**ADDENDUM 6**

PROJECT:  
**NEW NAPANEE WPCP**

TITLE:  
**EXISTING DIGESTER REPAIRS**

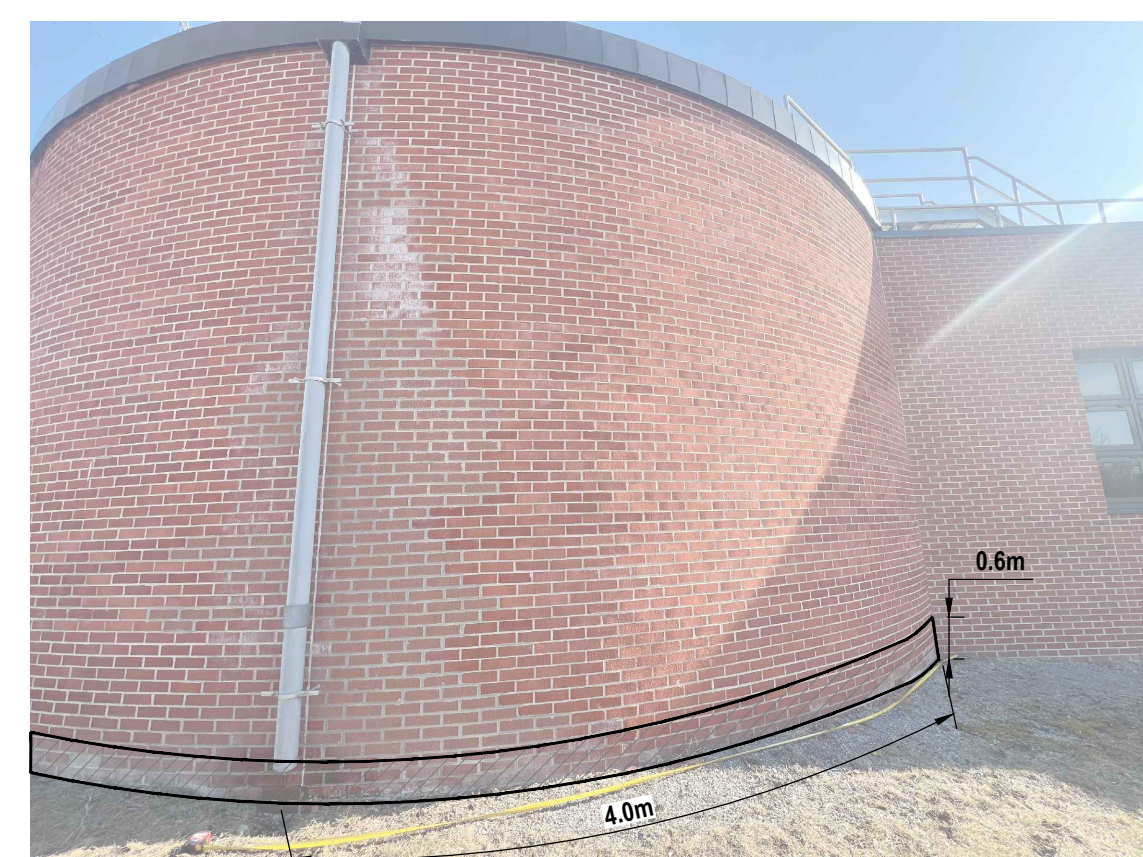
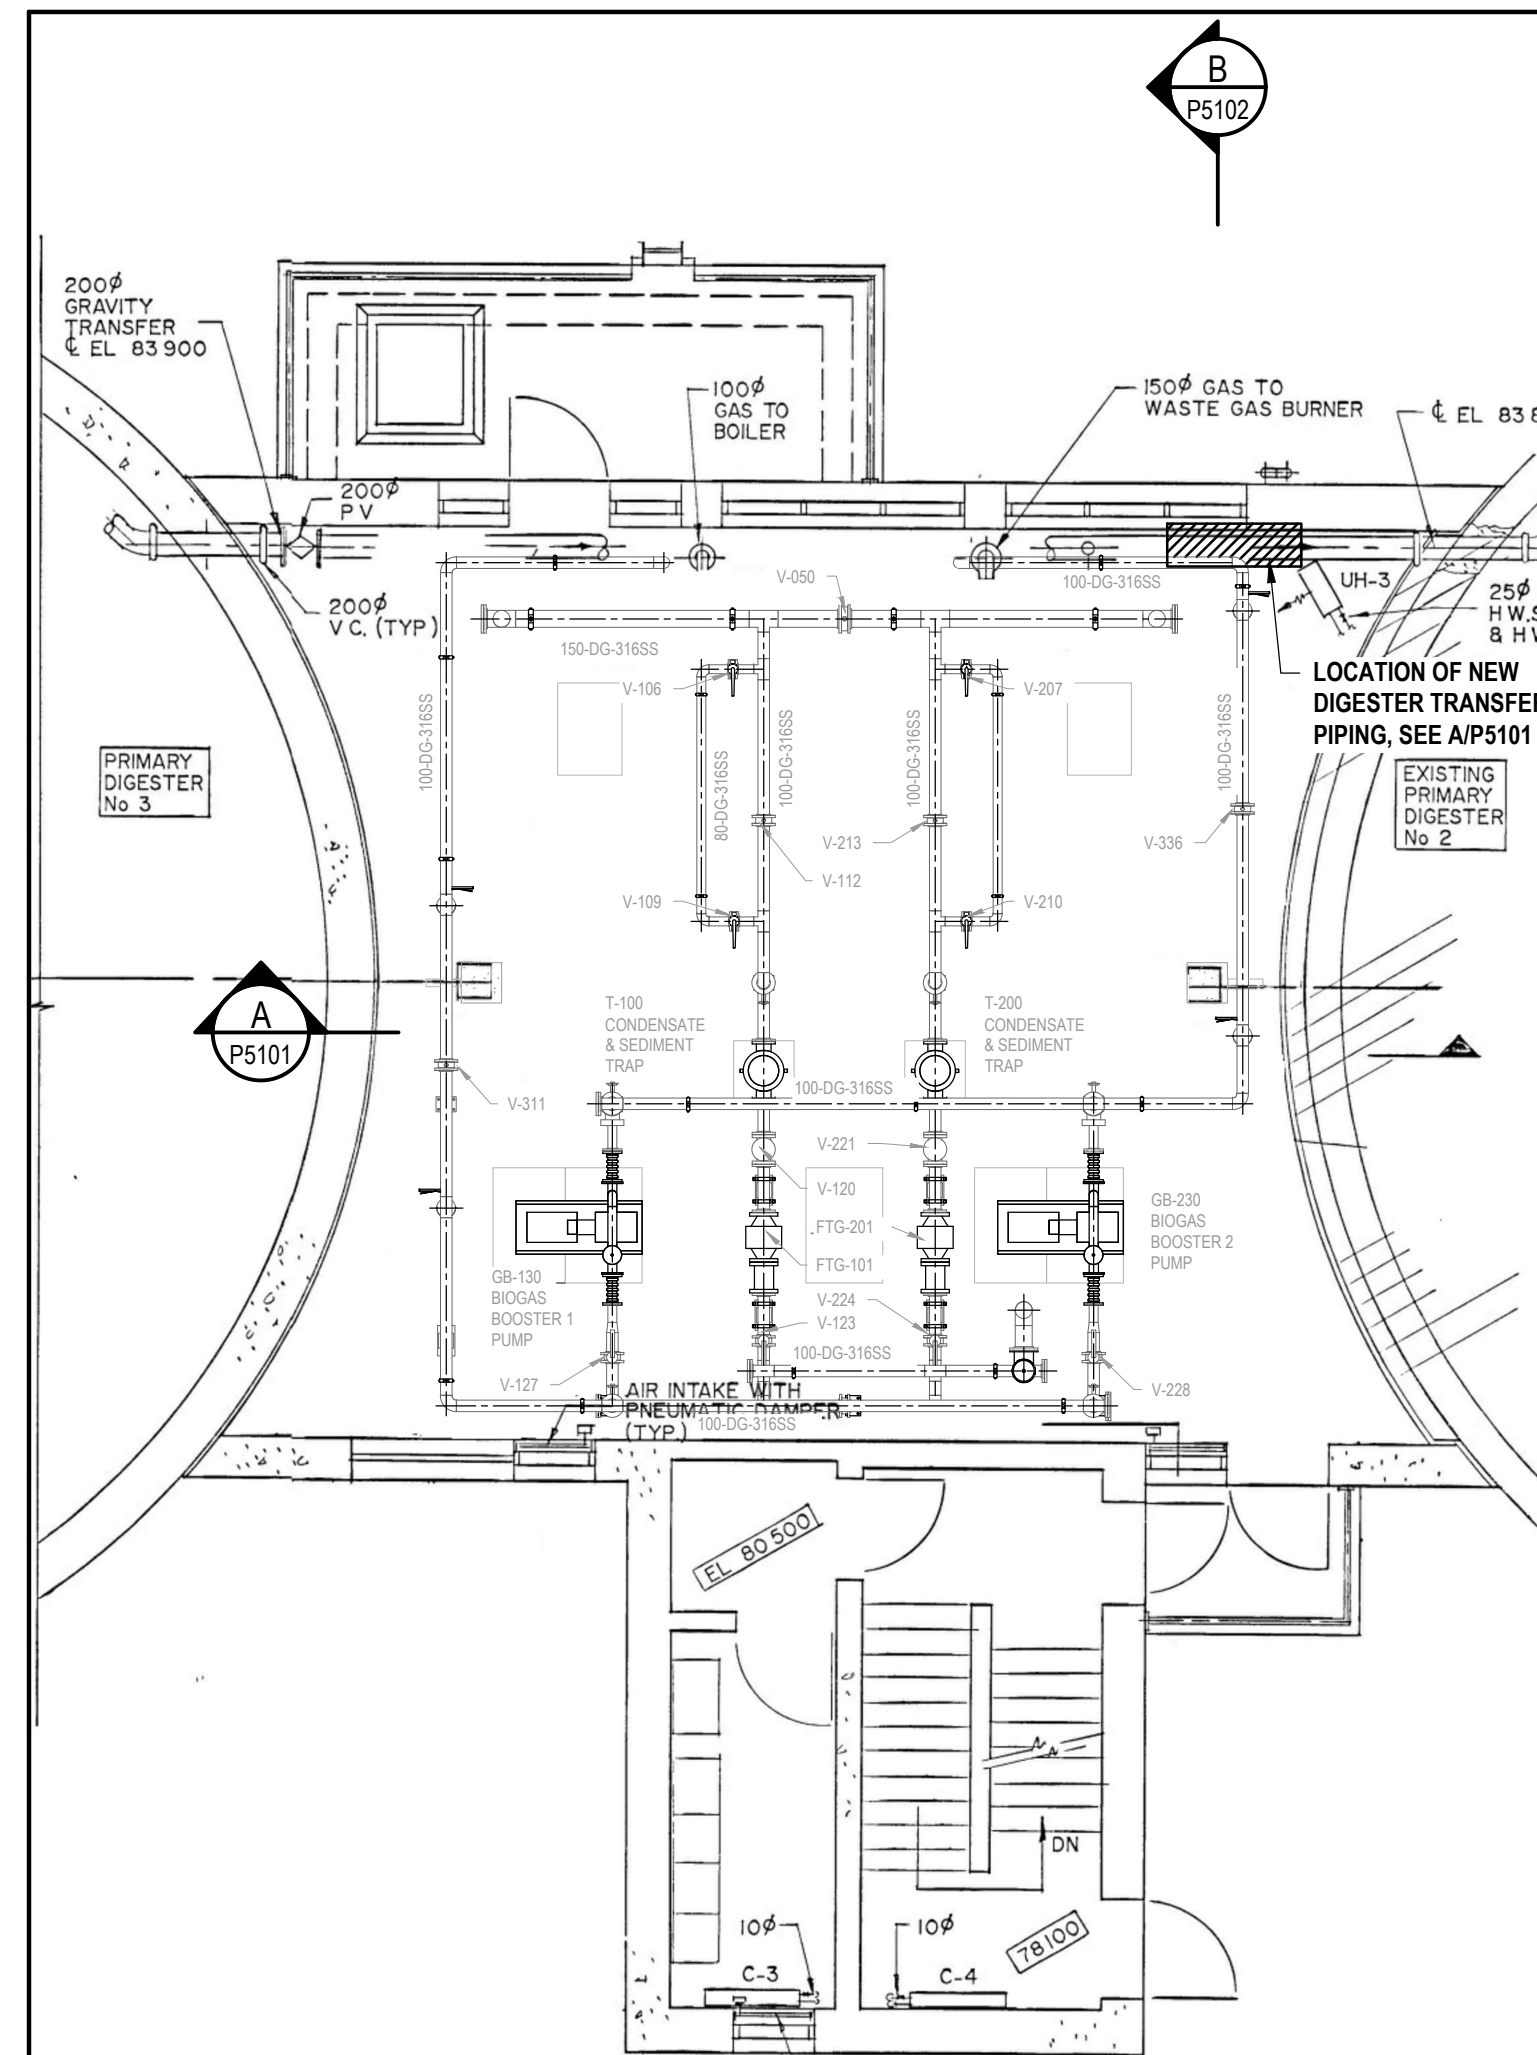
- .1 **Amend Drawing A5003** Room & Door Schedules as per the attached.
  - .1 Contractor to provide Leaf Material for Doors D-3202C and D-4102C as per modified Door Schedule.
- .2 **Add** Drawing A5101 providing direction for the Provisional Brick Repair.

- 1** **DIGESTER BRICK REPAIR WORK:** CONTRACTOR TO REMOVE AND REPLACE BRICK & MORTAR, VAPOUR BARRIER, INSULATION, AND BRICK TIES TO EXTENT OF HATCHED AREA SHOWN IN PHOTOGRAPHS. REPORT ANY DISCREPANCIES (INCLUDING BUT NOT LIMITED TO EFFLORESCENCE, FROST DAMAGE, SHRINKAGE, MOLD, ETC.) BACK TO THE CONSULTANT'S IMMEDIATELY UPON REMOVING EXISTING BRICKS.
- 2** **DIGESTER PARAPET FLASHING:** CONTRACTOR TO REMOVE AND REPLACE PREFINISHED METAL FLASHING TO EXTENT OF HATCHED AREA SHOWN IN PHOTOGRAPHS. CONTRACTOR TO COORDINATE WITH ROOFING MANUFACTURER FOR TIEING INTO EXISTING PARAPET FLASHING.
- 3** **DIGESTER RAINWATER LEADER:** CONTRACTOR TO REMOVE AND REINSTALL EXISTING RAINWATER LEADER. MAKE GOOD ANY DAMAGES TO FLASHING OR WIRE MESH CAUSED BY RAINWATER LEADER REMOVAL.

| DRAWN BY:<br>K.B.W.  | DRAWING NO.<br>P5101 |

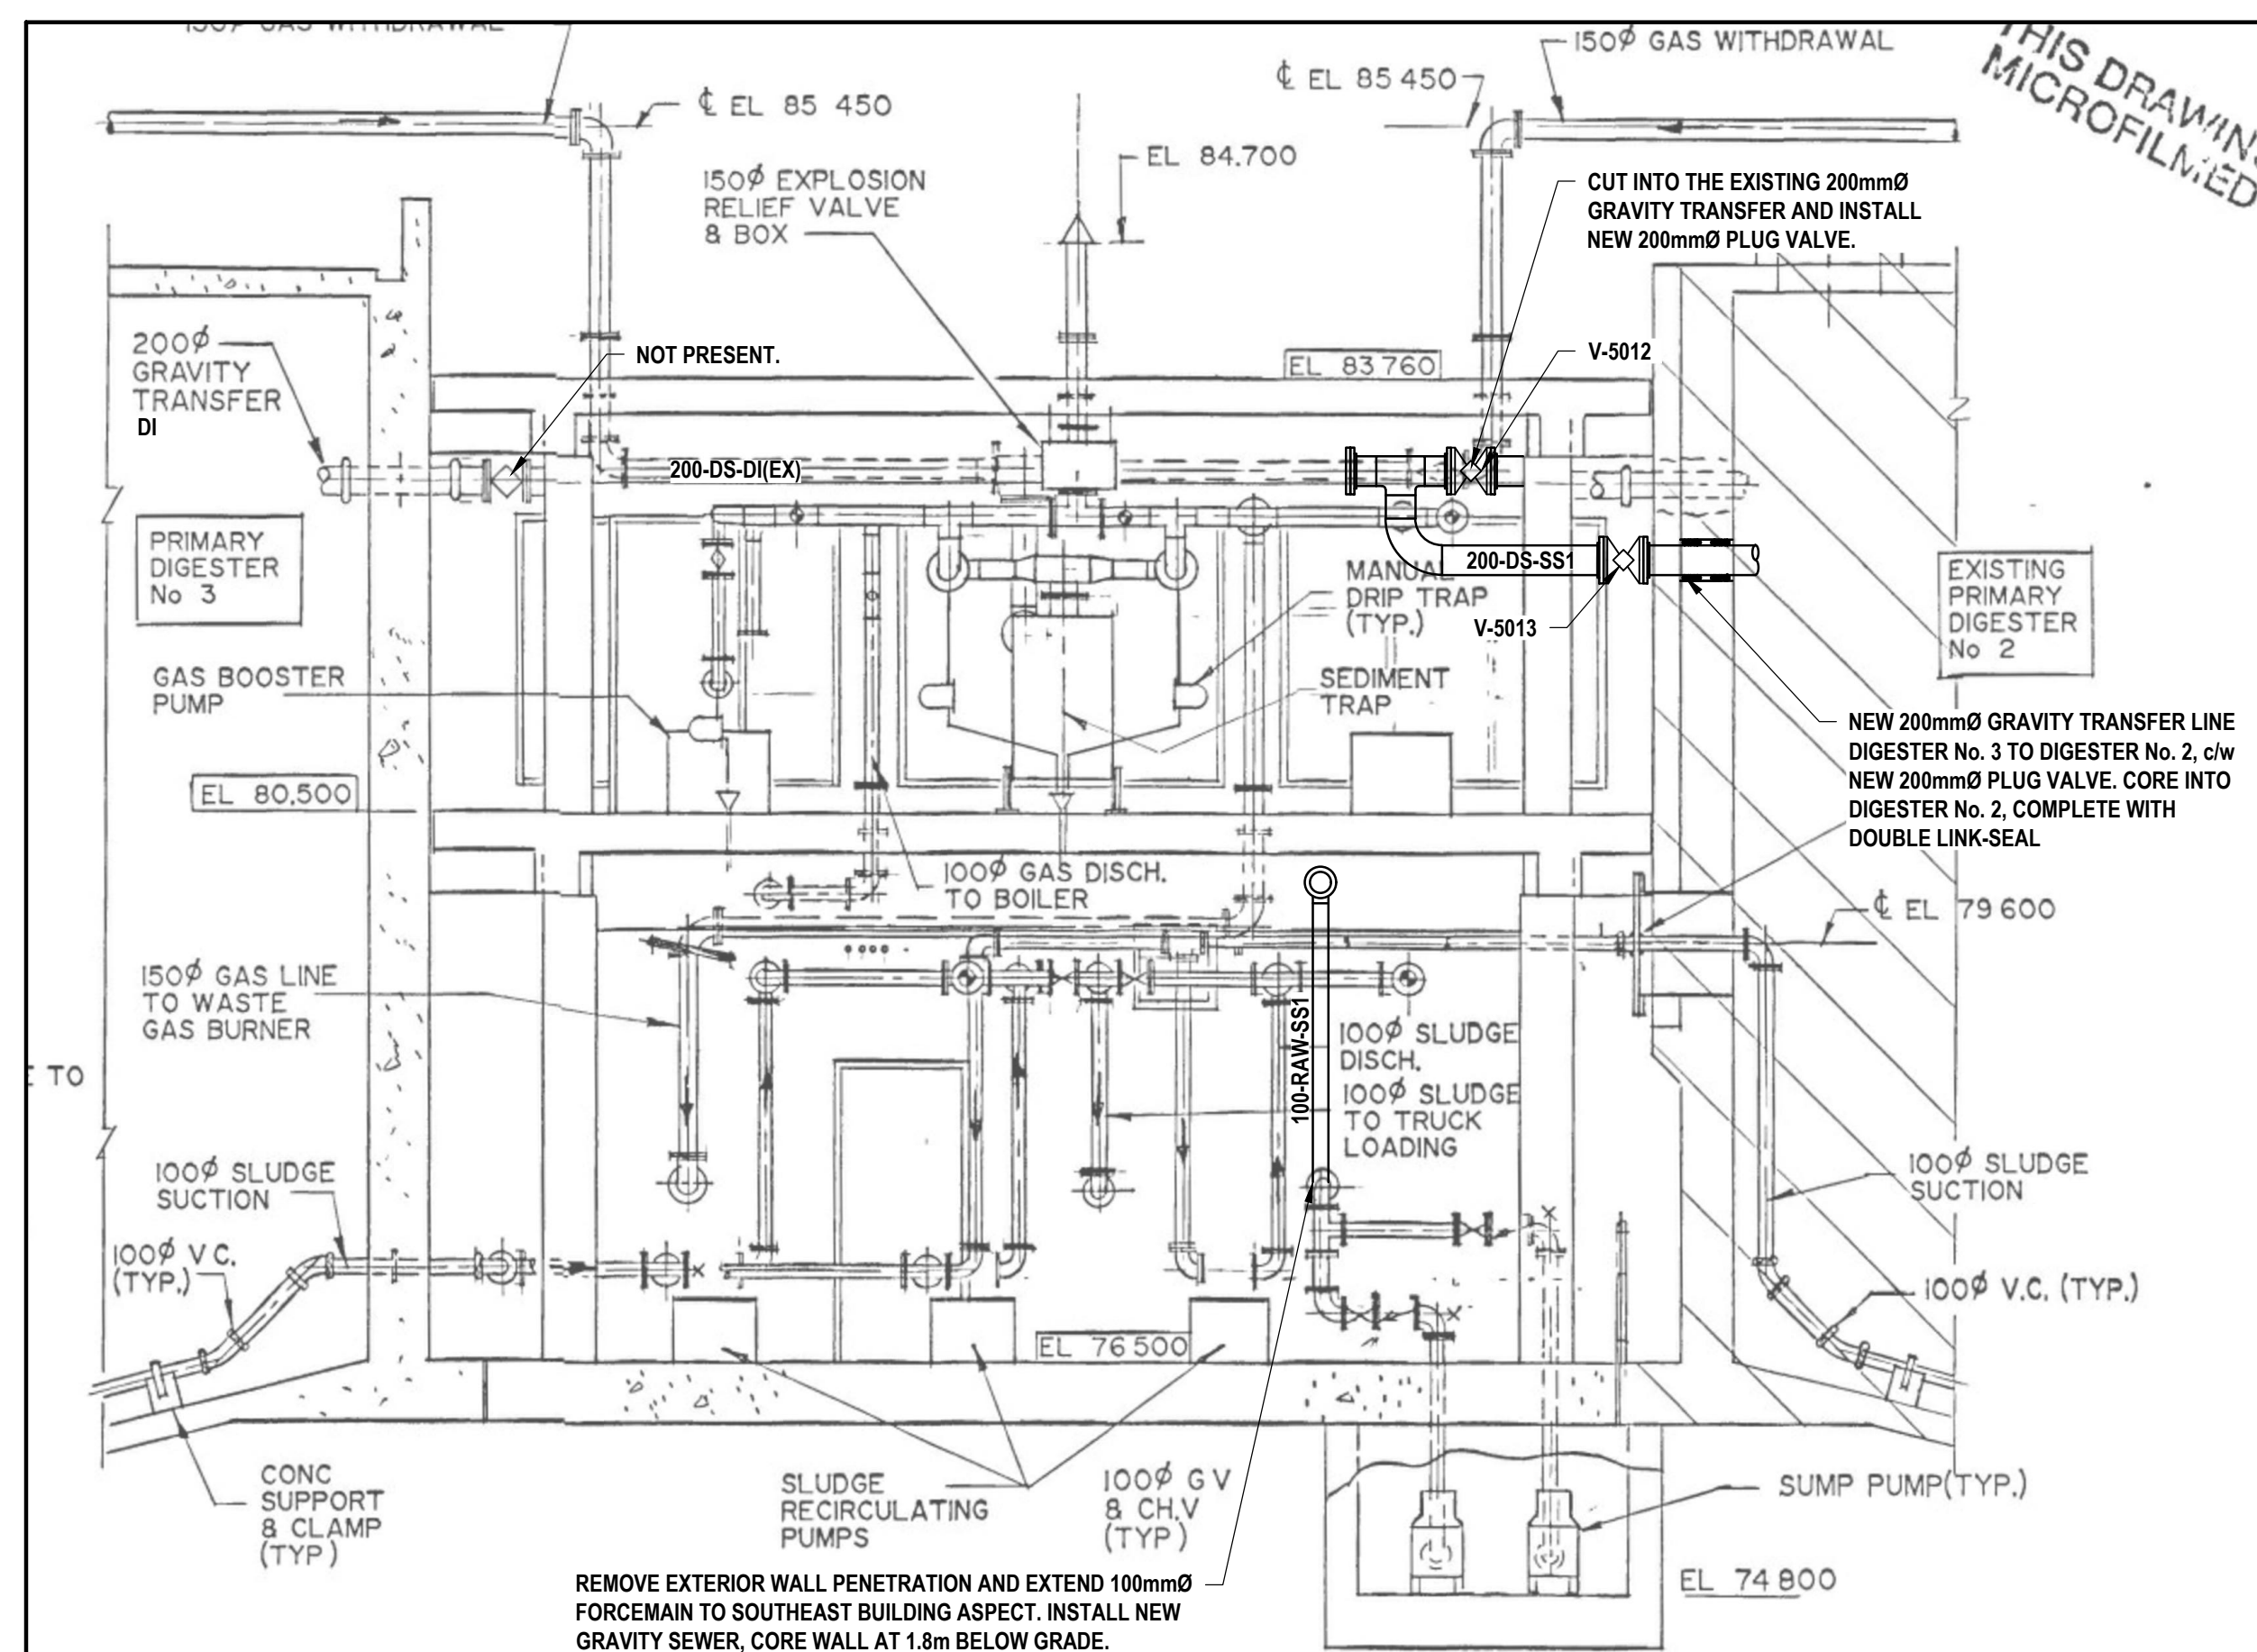
- .10 Drawing P5101
  - .1 **Amend** Drawing P5101 as per the attached.
- .11 Drawing P5102
  - .1 **Amend** Drawing P5102 as per the attached.
- .12 **Add** Drawing P5103 as per the attached.
